**Addendum #1**

Addendum Date: December 3, 2024

Project: Swift Community Center

**A-303**

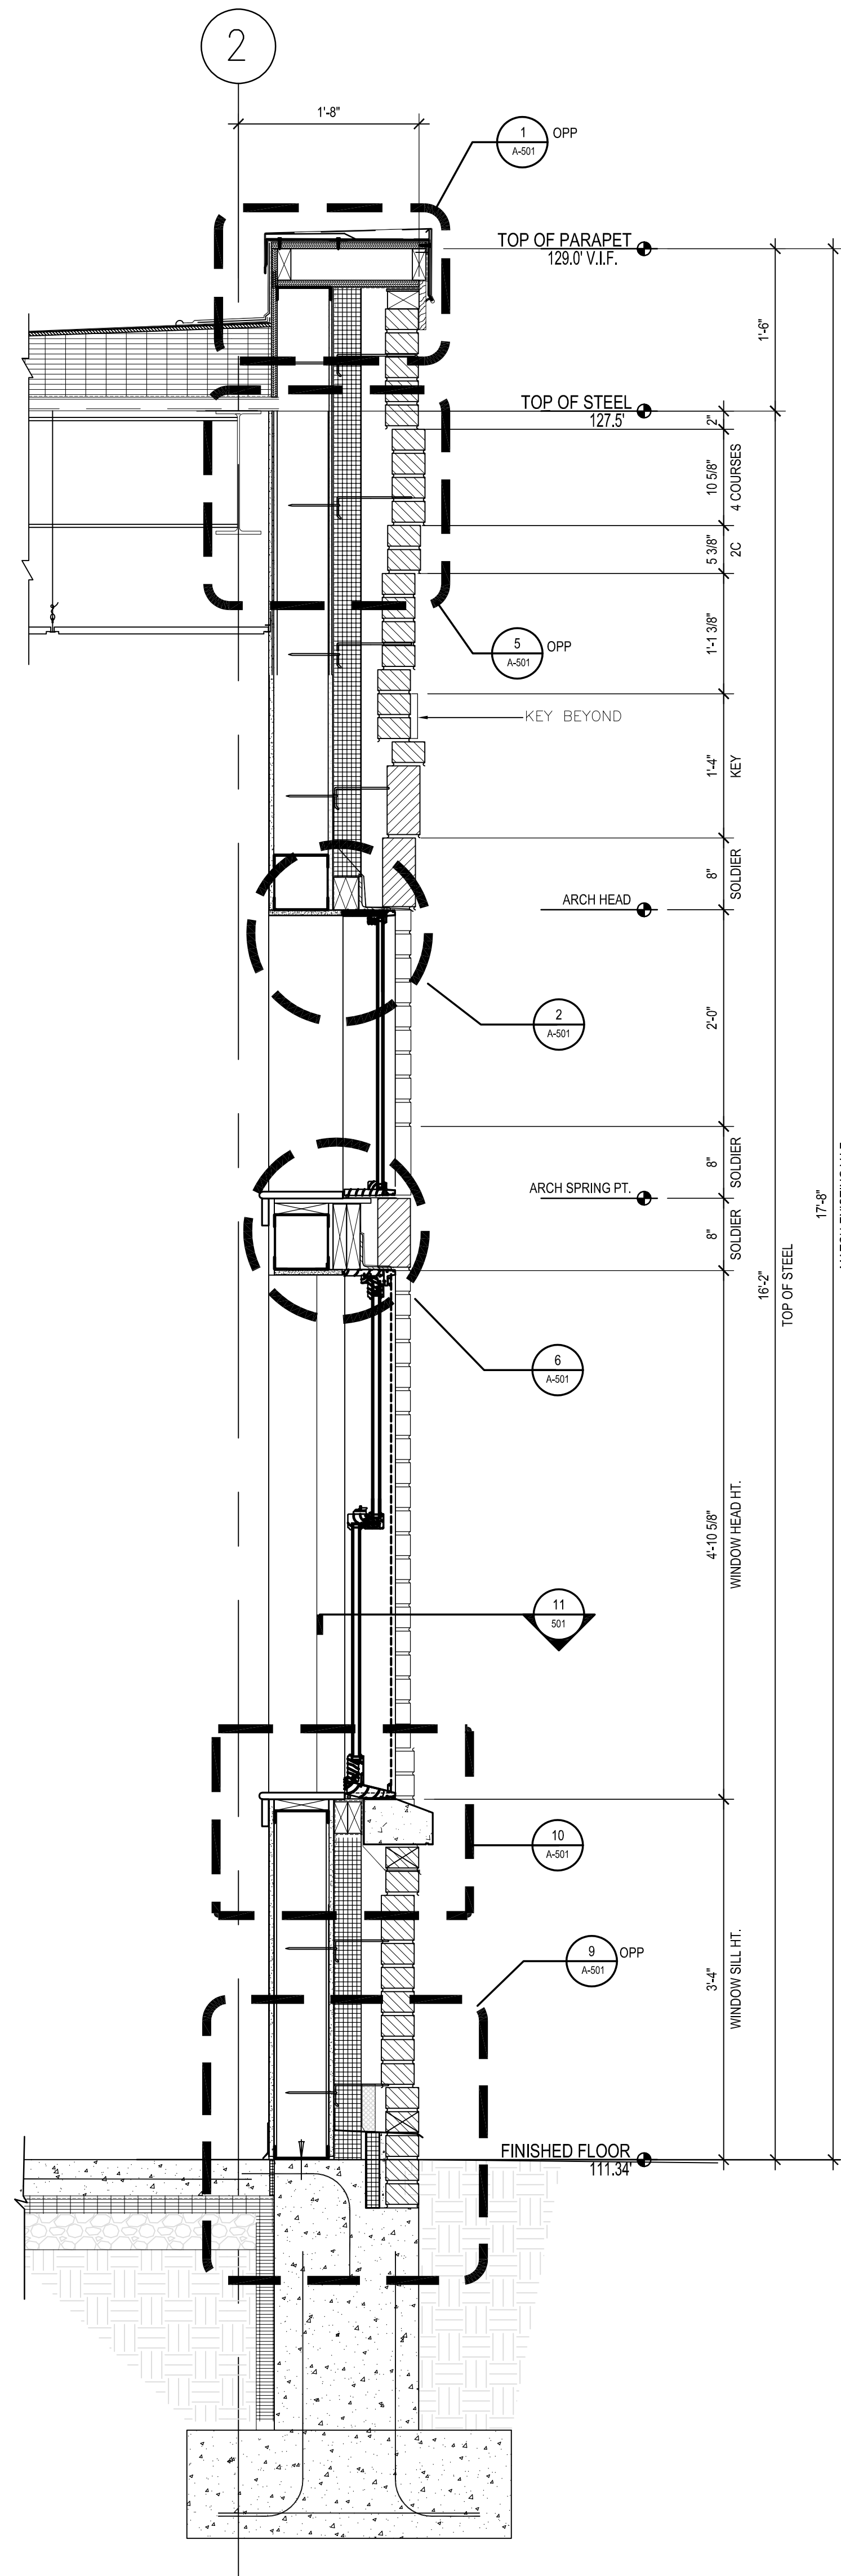
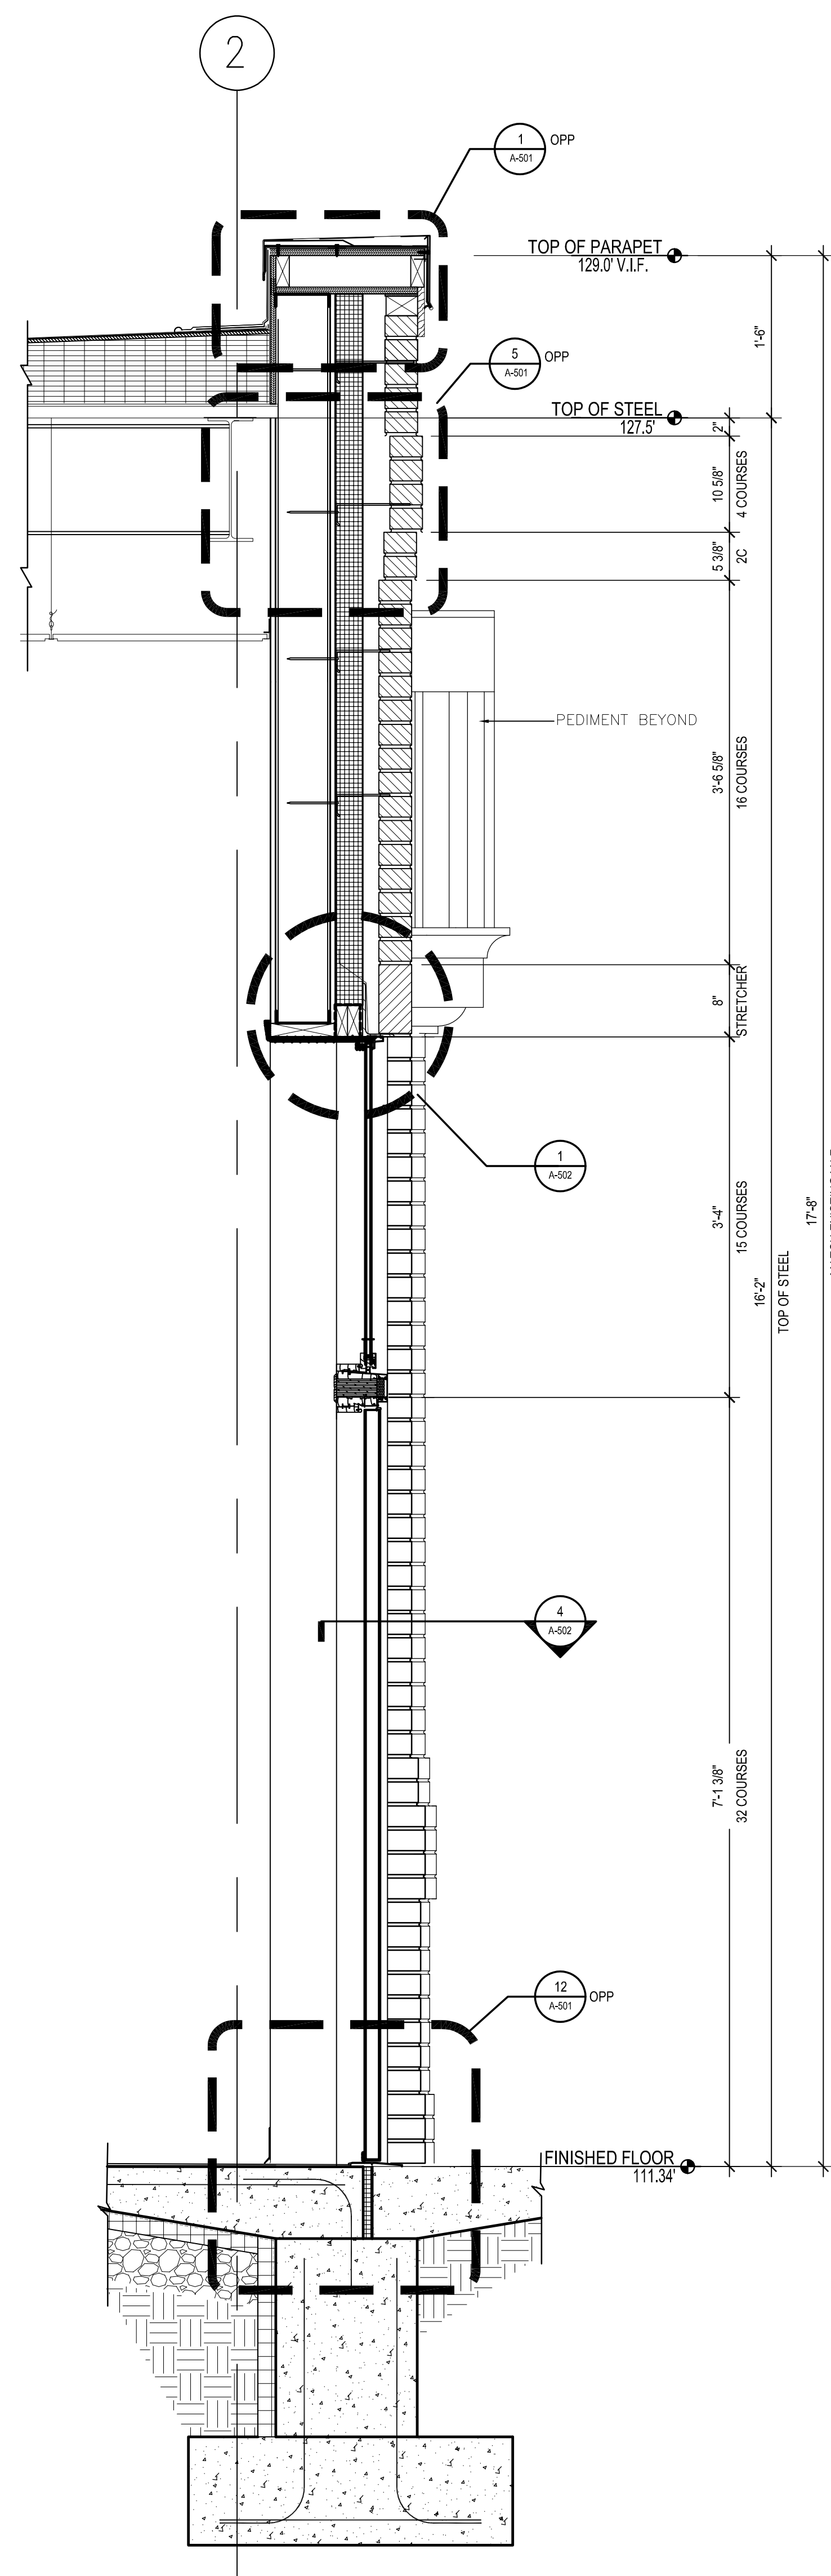
- Q8. Please provide typical wall type for exterior wall  
**A - Refer to Revised Sheets A302 and A303. (Attached)**
- Q9. There are no Fire Alarm drawings included in the drawing set. What are the fire safety requirements for the new space? Who is the manufacturer of the existing FA Panel?

- Q36.** 3/A501 references 1/A302 for wall types, but none are shown, please advise.  
**A - *Refer to Revised Sheets A302 and A303. (Attached)***
- Q37.** Can you confirm specifications for Div 3 and 5 are per sheet S000?

SHEET TITLE: ELECTRICAL COVER SHEET

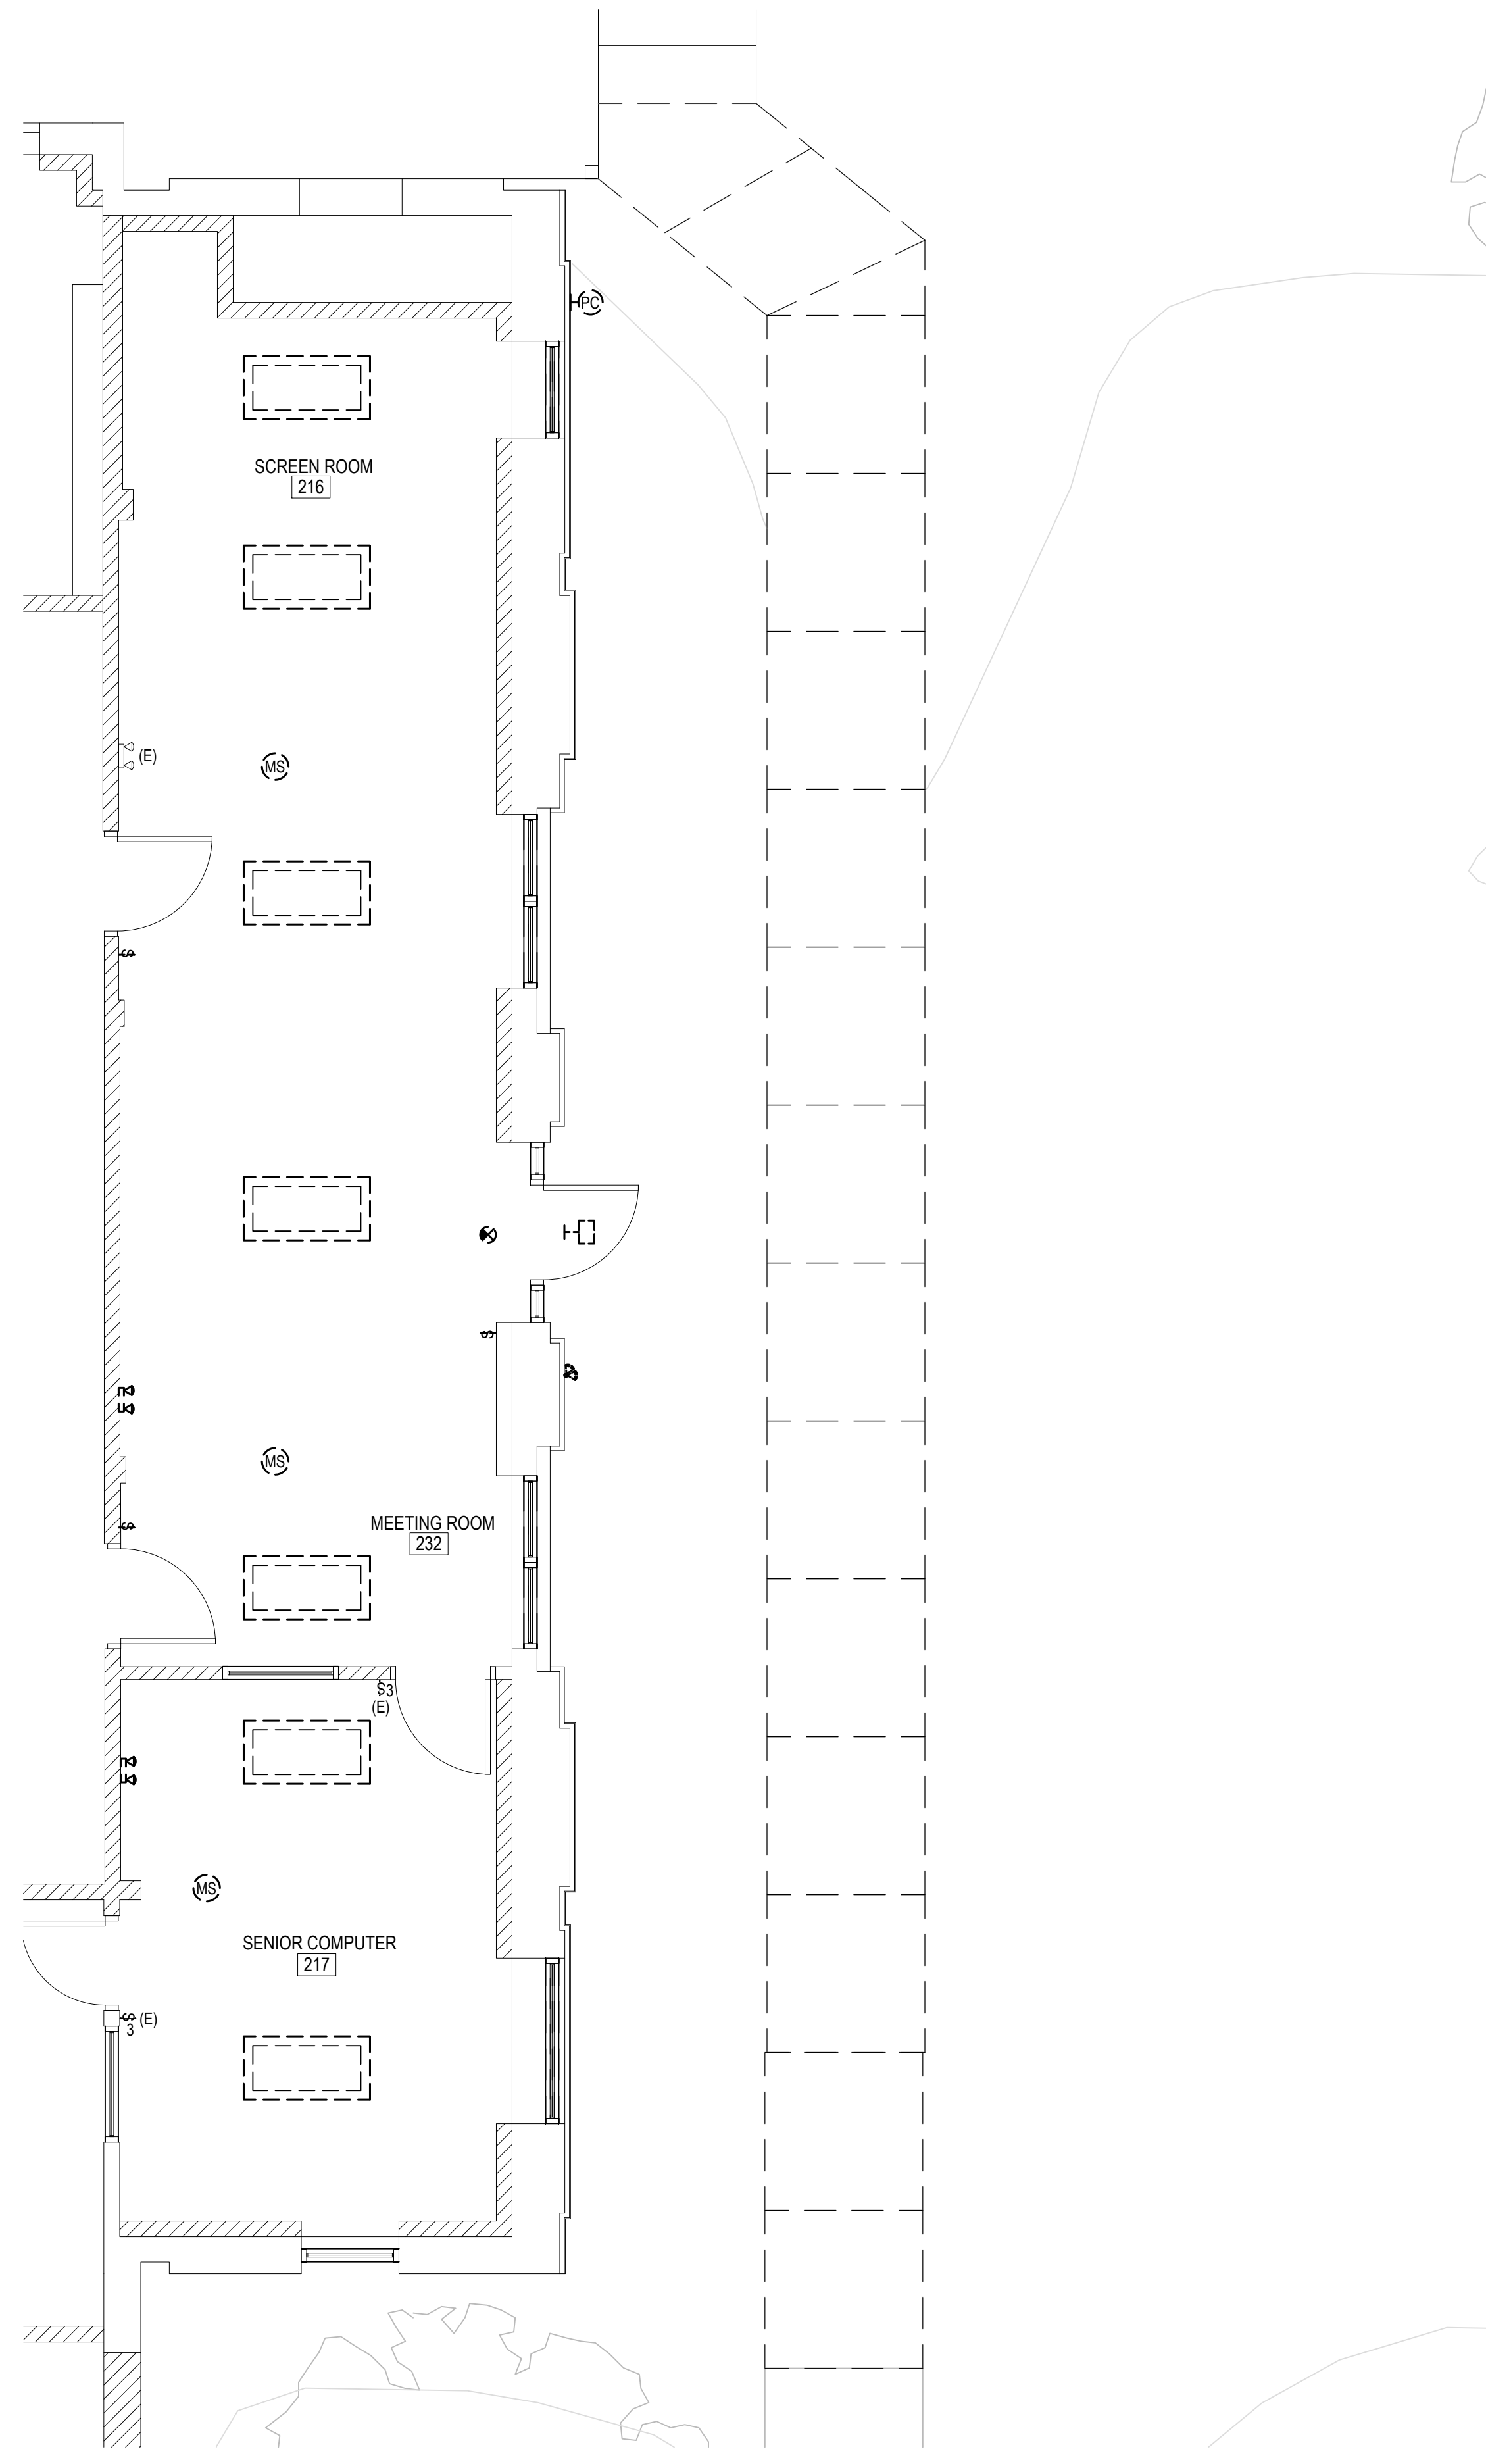
1. E-000
  - a. Added fire alarm devices to the symbol legend.
  - b. Added a Fire alarm system description.
2. ED101
  - a. Added fire alarm devices to be demolished.
3. E-101
  - a. Added new fire alarm devices.
  - b. Revised the location of the new electrical panel PL1A to the adjacent wall with the storage room.
4. E-600
  - a. Added a circuit breaker for the added NAC panel.
  - b. Revised the description of PL1A-18.
5. M-101
  - a. General notes added
6. M-500
  - a. Diffuser and return grille schedules updated to reflect drawings.
